Change Note		CN-063
Change to: Technical Assumption 45 and 61		
Description: Primary Differential Pressure tests		
References: Paragraphs 2.20, 2.21, 2.22, Table 1		
Change originator: JA		Date of request: 15/12/21
Rev: 01	Date authored: 17/01/22	Proposed change to assumption: Y

Figure 1: Proposed secondary flows and DP for DHW dynamic test (2a & 2b)

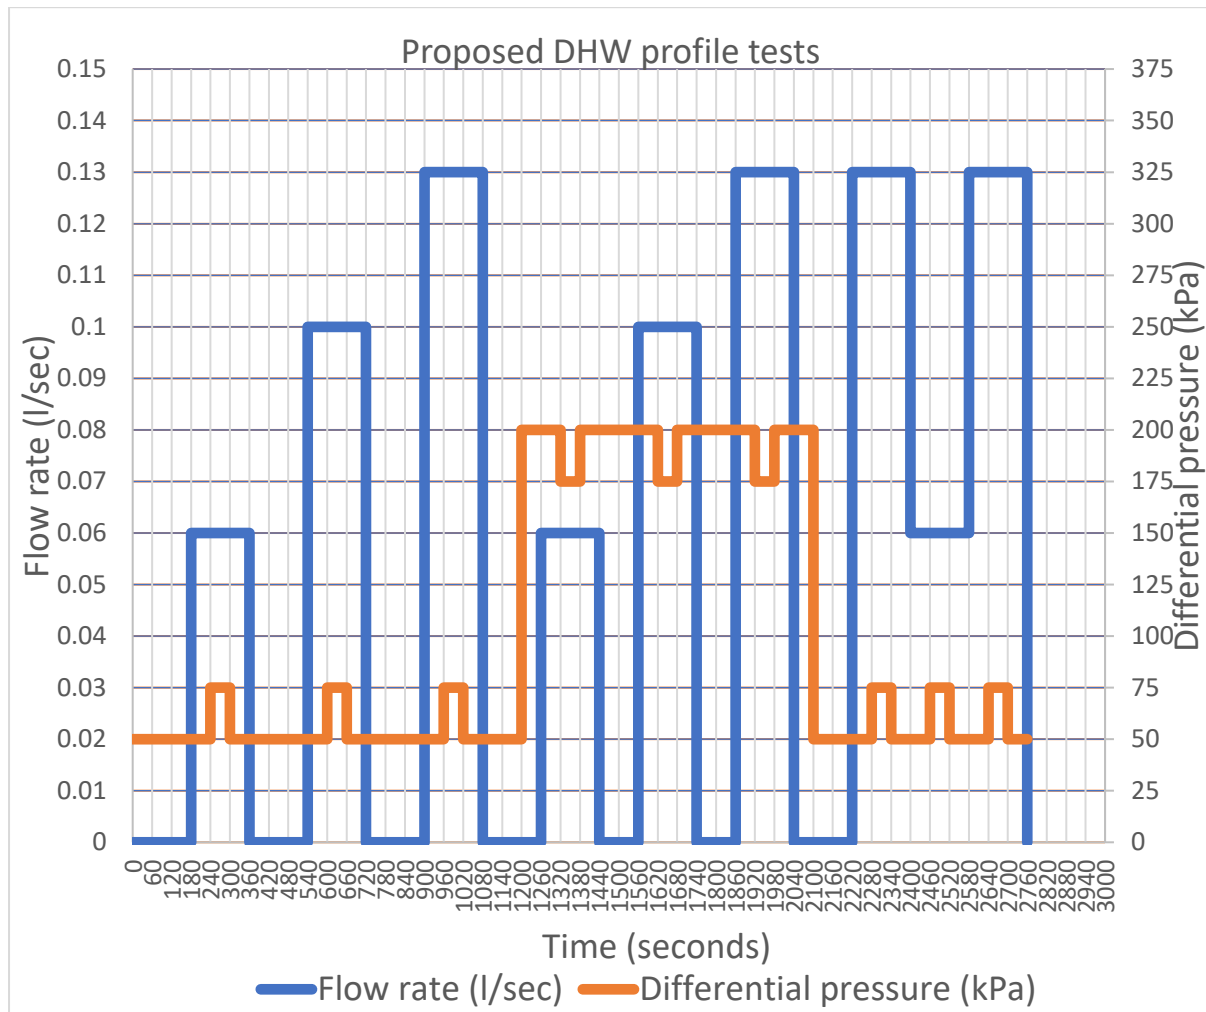
Based on previous considerations it is proposed to perform a Dynamic DHW demand test (tests 2a and 2b) with variable DP on the primary. The new test will show the performance of the HIU at different flows with 50 kPa and 200 kPa of DP on the primary. This will show how the HIU would perform in the reference building at maximum and minimum DP.

A 25 kPa fluctuation in DP has also been added to assess the HIU reaction to DP changes during the typically operating conditions. In order to assess the HIUs performance at low (50 kPa) and high (200 kPa), the 25 kPa fluctuation have been introduced within the 180 second low (0.06 l/s), medium (0.10 l/s), and high (0.13 l/s) flow rate tests at both DPs.

Figure 1 shows the proposed test flows and DP values over time.
